Application for Licence Amendment

Licence Number	L8422/2010/2
Licence Holder	Edna May Operations Pty Ltd
ACN	136 365 001
File Number	DER2017/000298-1
Premises	Edna May Gold Project Warrachuppin Road WESTONIA WA 6423 Legal description M77/88, M77/110, M77/124, G77/122 and L77/18
Date of Report	3 November 2021
Decision	Amendment Granted

Figure 2 IWL/TSF drainage system and monitoring bores

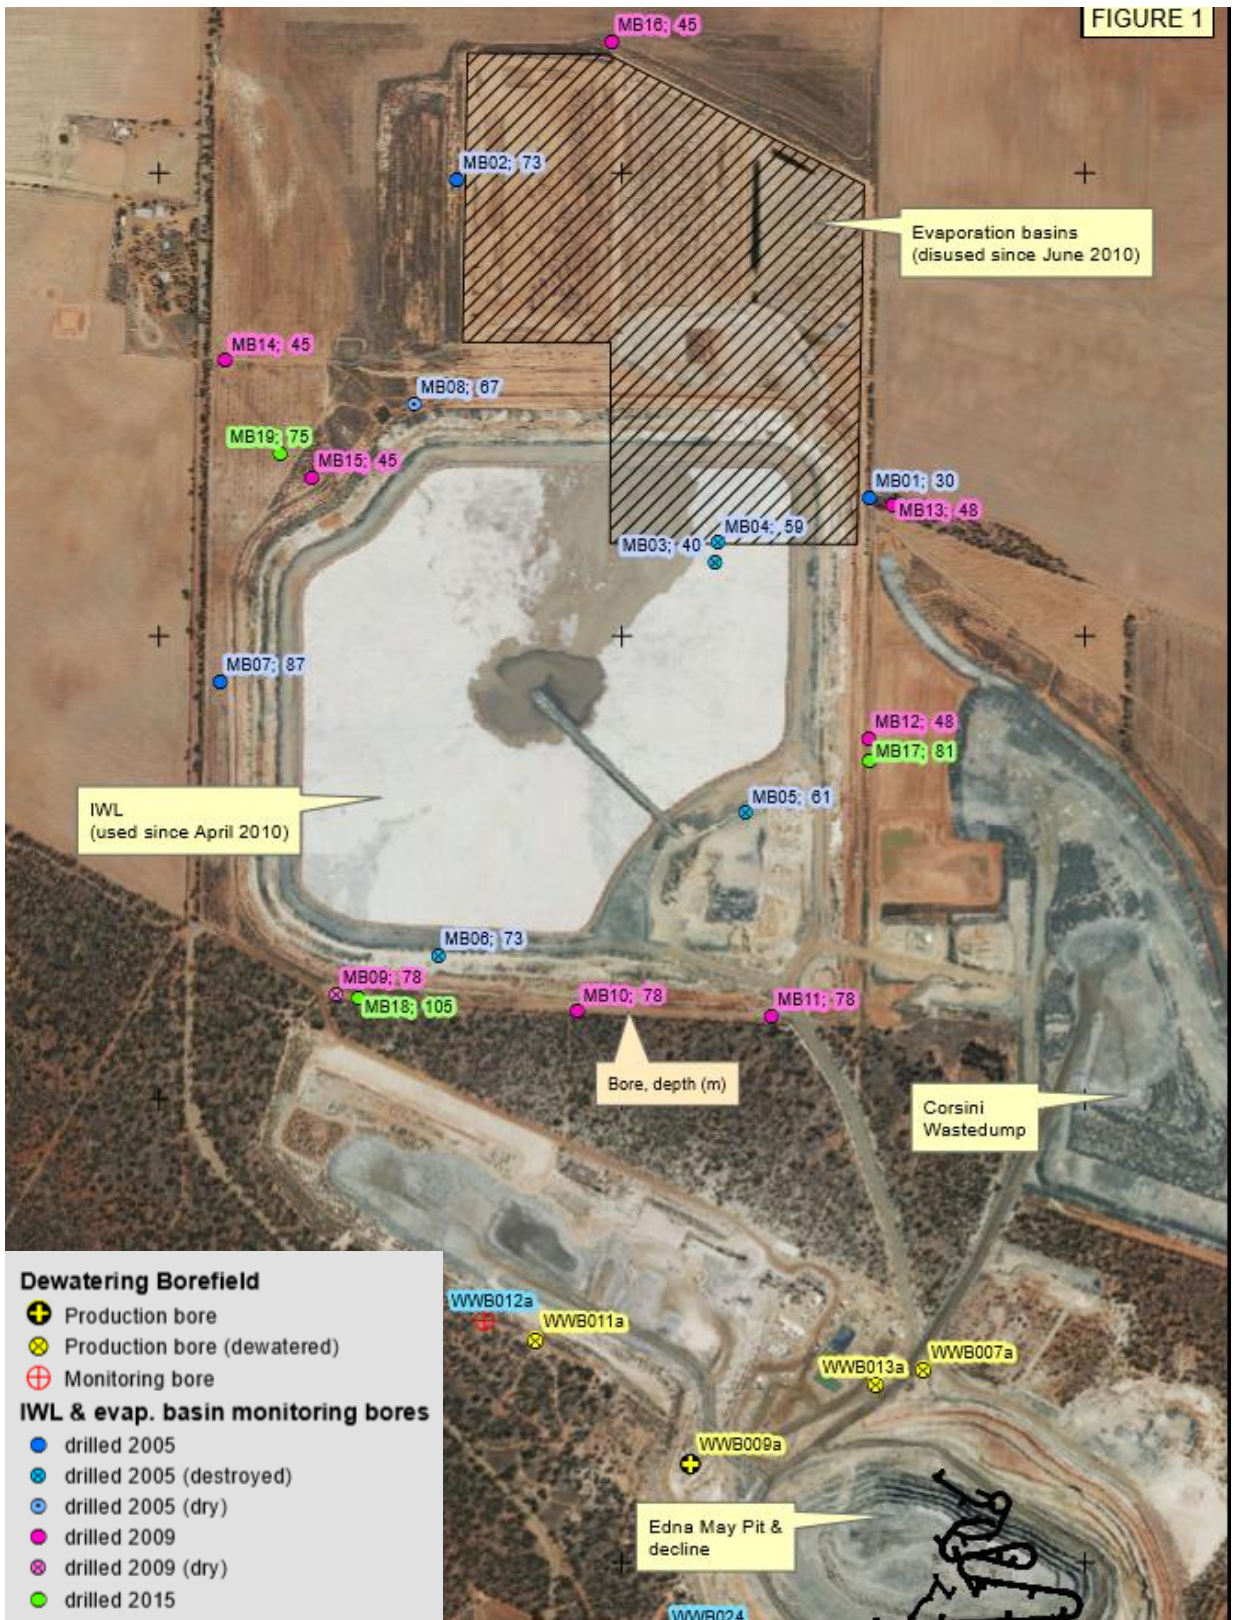
Eighteen vibrating wire piezometers were installed at six locations in the IWL/TSF embankment (Figure 2) and have been reported by Rockwater (2018) as recording very low or negative pore pressures, indicating dry embankments.

- An underdrainage system beneath the centre of the IWL/TSF and around the upstream toe of the IWL embankment;
- A cut-off trench underneath the upstream toe of the main embankment to restrict horizontal seepage; and
- A 2m deep seepage interception trench located between the IWL/TSF embankment and the surface water diversion bund (Figure 2).

Monitoring of ambient groundwater quality is currently required as part of condition 22 (Table 7). This includes 11 monitoring bores (Figure 2) surrounding the TSF. A standing water level limit of 3m bgl and a WADCN limit of <0.5mg/L are currently on the licence. Standing water levels are measured monthly and groundwater quality quarterly.

Figure 3 IWL/TSF monitoring bores (additional detail)

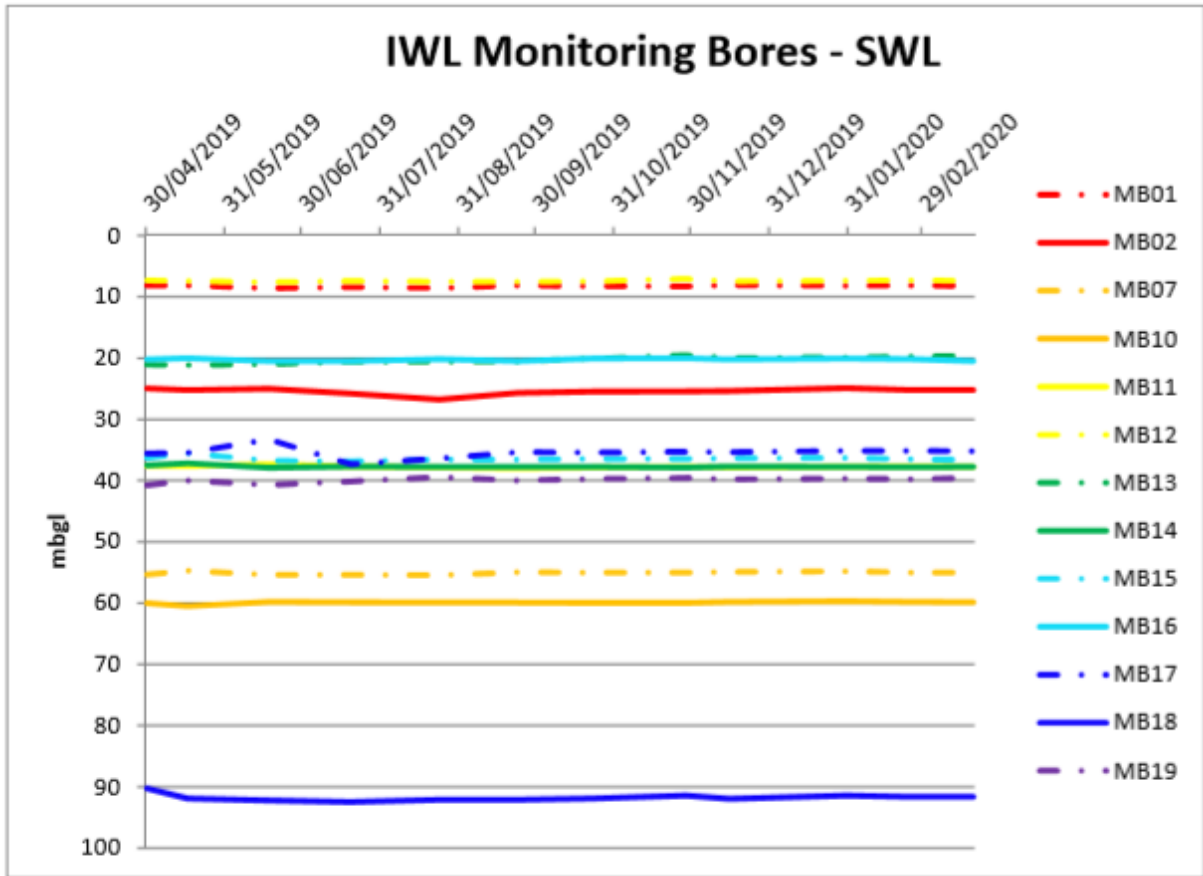
Rockwater (2018) suggests that it's unlikely water levels around the IWL/TSF would rise enough for contamination to be brought to the near surface due to the large cone of depression (see MB18 – Figure 3) produced by dewatering of Edna May pit. However, groundwater monitoring bore MB12, along the eastern IWL/TSF margin, returned a standing water level 6.38m bgl in April 2017 and 7.08m bgl in 2020 (originally 40.03m bgl in 2009). Standing water levels in MB13 and MB17 have risen by 2.17 and 1.12m bgl (2020) since their original installation. Water levels in all other monitoring bores have dropped.
